**ARCHITECTURAL
REVIEW COMMITTEE**

ARCHITECTURAL REVIEW COMMITTEE MINUTES MAY 10, 2023

Strand Associates, Inc.® (Strand) has finished its review of the construction drawings and Storm Water & Erosion Control Calculations resubmittal for the Quest Interiors Development that were received from Excel Engineering, Inc. (Excel) on May 22, 2023, for conformance with the Town specifications and general engineering practices. Before construction may begin, the contractor shall submit all required permits for the development to the state, Wisconsin Department of Natural Resources, Town, and any other relevant agencies. New drawings, stormwater management plan and calculations, and a letter describing the revisions should be returned to Strand after the following concerns have been addressed. Excel's responses to Strand's original comments are *italicized* and Strand's most recent comments are in **bold**.

CIVIL EXISTING SITE AND DEMOLITION PLAN

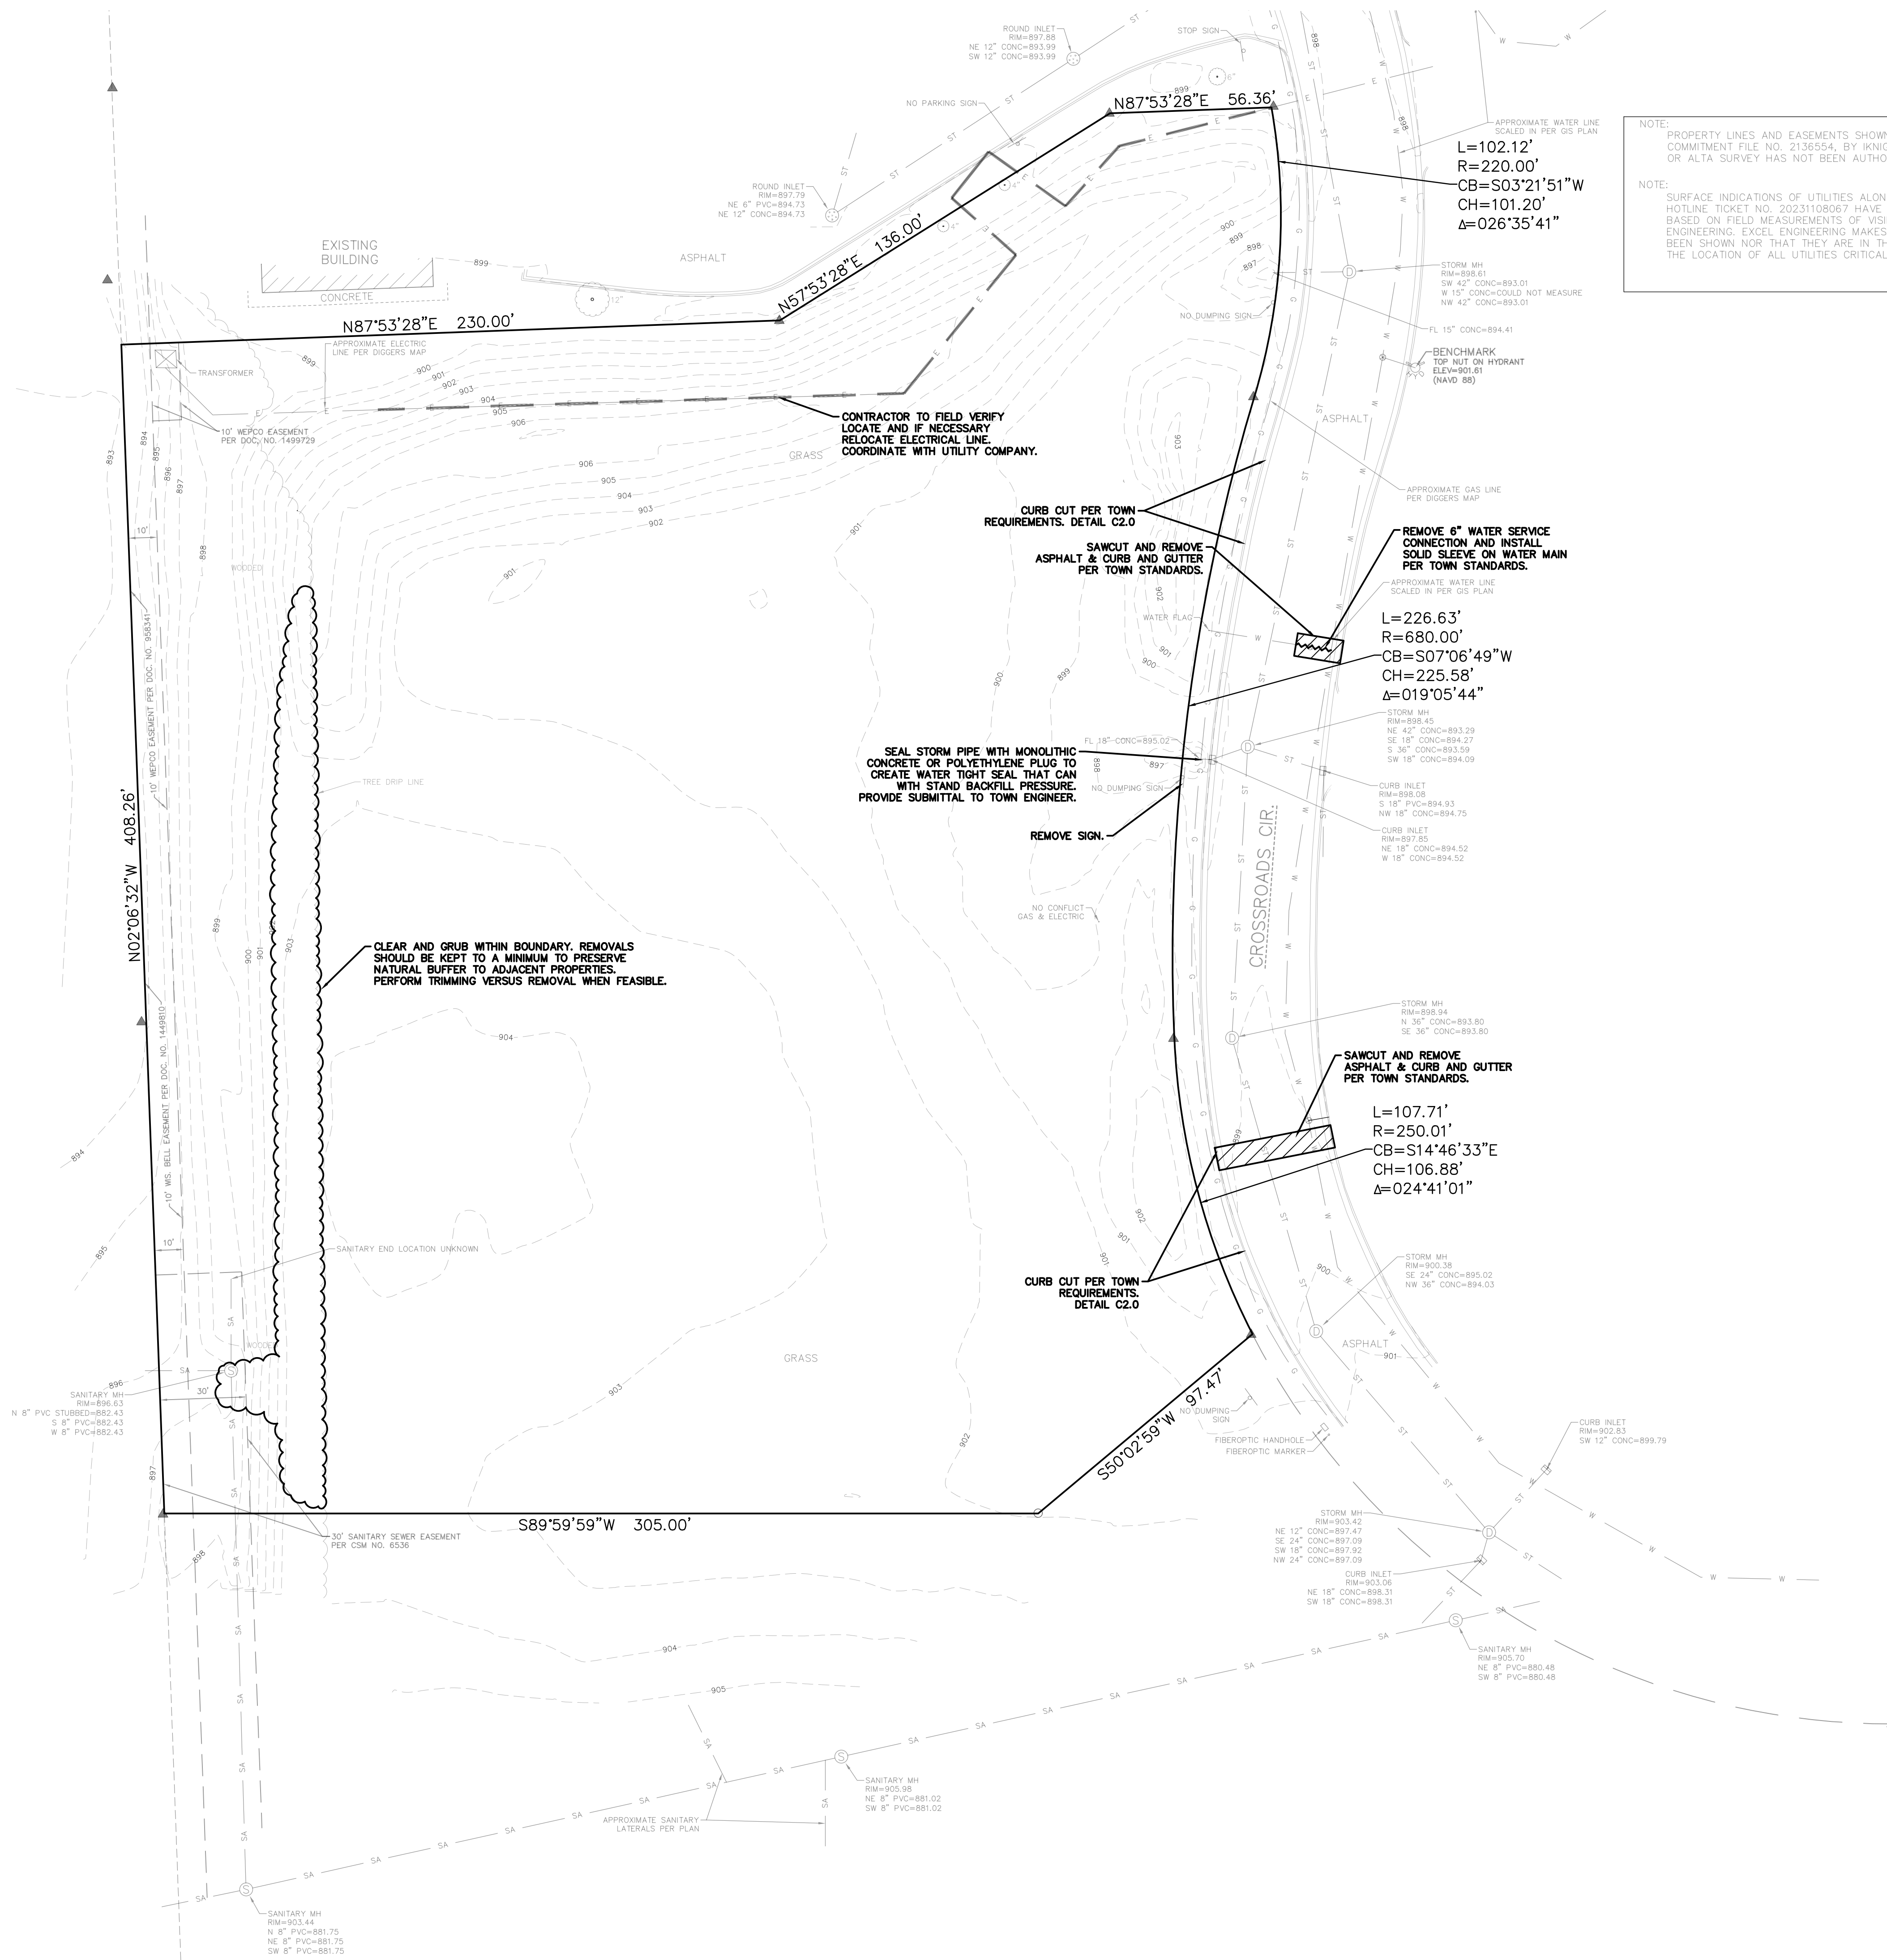
Strand's May 3, 2023, Comment—Specifications or a detail should be provided describing or showing how the storm sewer pipe will be plugged.

Excel's May 22, 2023, Response—Call out note on C1.0 has been revised to provide more directive on plug.

Strand's Current Response—The revised note was reviewed and is acceptable.

CIVIL SITE PLAN

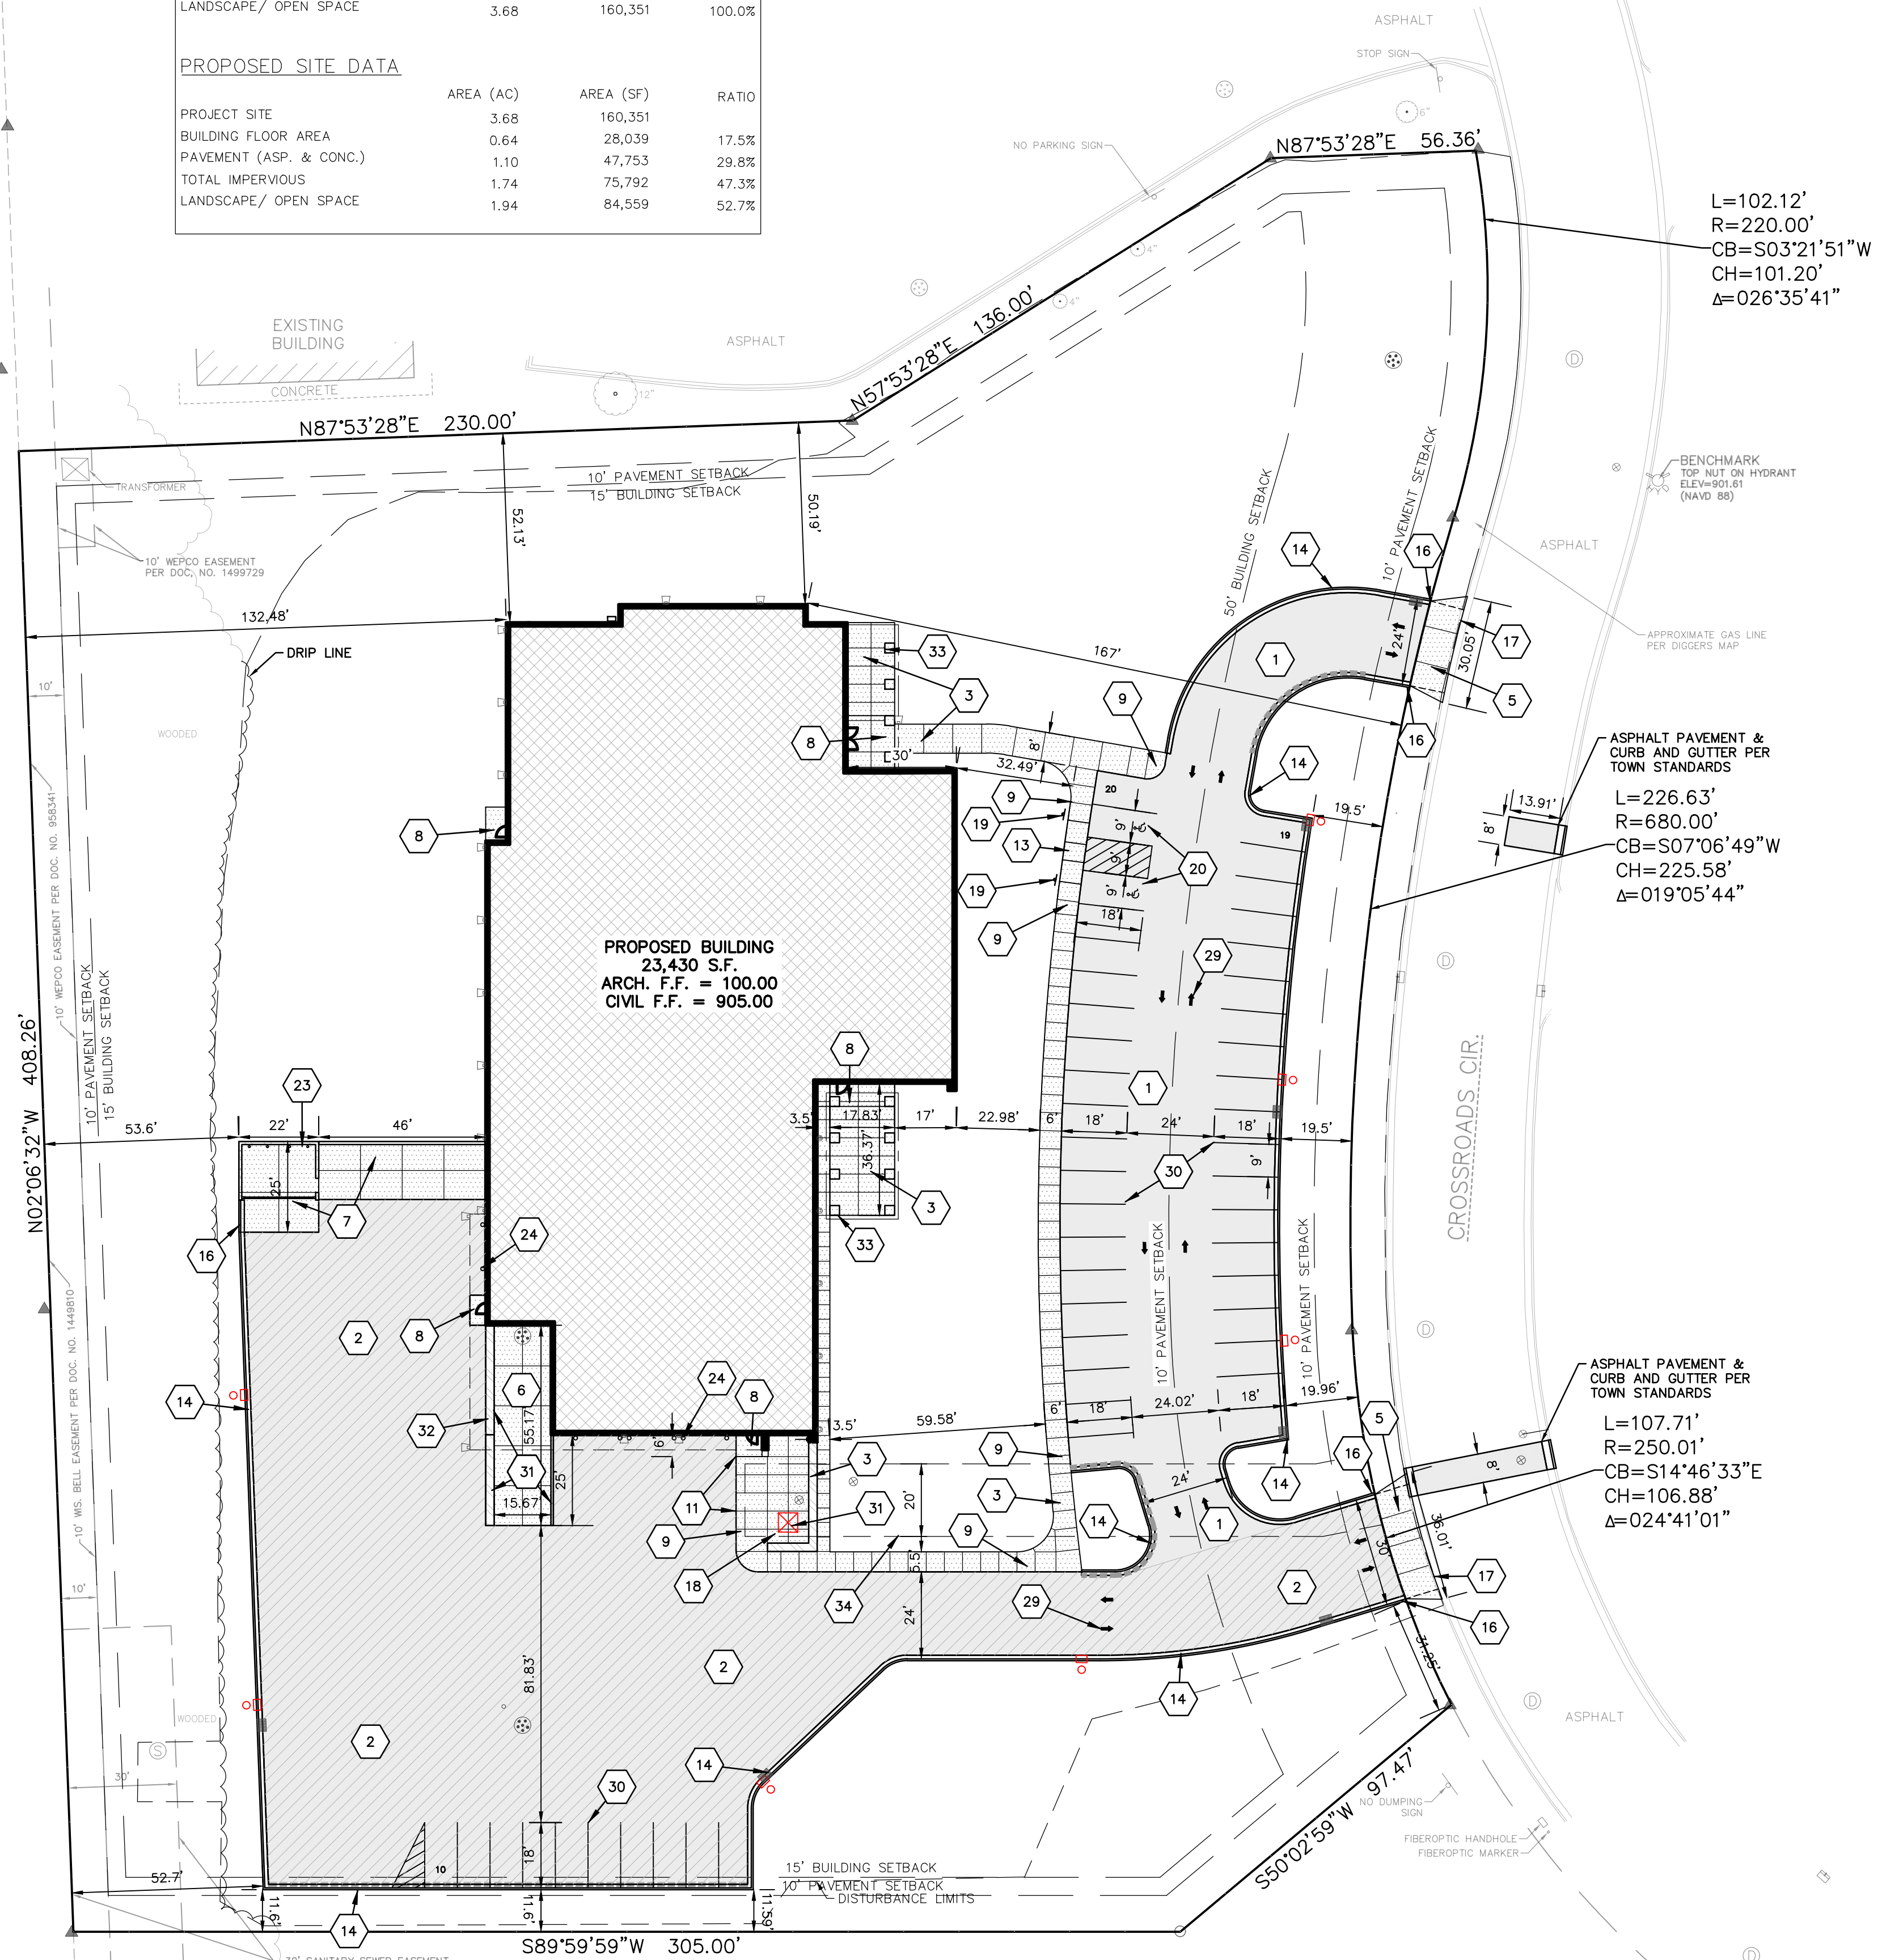
1. Strand’s May 3, 2023, Comment–According to 17.06(3)(c)(4) in the Town ordinance, the minimum dimensions for all parking spaces provided for use by physically disabled shall be 12 feet by 18 feet. It appears that these stalls are 9 feet by 18 feet.

2. Strand’s May 3, 2023, Comment–There is a callout for a Keynote 27 in the plan, but there is no description for “27” in the Keynote legend.

3. Strand’s May 3, 2023, Comment–A turning movement exhibit should be provided to verify the largest vehicle (including any emergency vehicles) that will access the site can perform the required turning movements with the proposed layout.

Excel’s May 22, 2023, Response–The plans shows (2) two 9-foot by 18-foot stalls with a shared 9-foot van accessible aisle. Taking 4.5-feet of the shared stall plus the 9-foot stall provides a 13.5-foot area meeting the code requirements. This will also be discussed at the PC meeting.

Strand’s Current Response–Based on the width of the accessible route, there appears to be adequate space for parking and access and would be able to accommodate cars and vans.

Excel’s May 22, 2023, Response–This keynote has been removed from the plan.

Strand’s Current Response–It was verified the keynote was removed.

Excel’s May 22, 2023, Response–A truck turning exhibit is included in the resubmittal.

Strand’s Current Response–A turning template was provided for a WB-67 interstate semi-trailer and it appears it will be able to access the southern portion of the site and back into the loading dock area. The Town Fire Department should verify whether emergency vehicles, such as a fire truck, should be evaluated for access in the eastern parking lot or northern driveway.
